Better use for reserved bits in ACT

Ragnar Jonsson

July 13, 2026

CRC6 Block Diagram

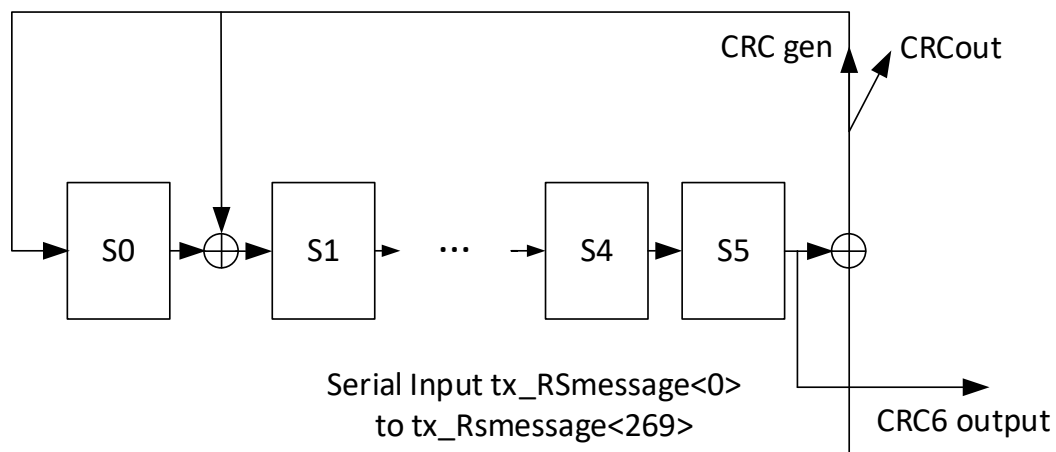
- The CRC6 proposed in this document is very similar to the CRC16 used in Clause 55
- The figure on the left shows the CRC6 implementation, in the same style as figure 55-27
- This figure might enhance the clarity of new Clause 191.4.2.2.14a (see change #9)
- The editor has full editorial license to decide if this figure should be included with Clause 191.4.2.2.14a
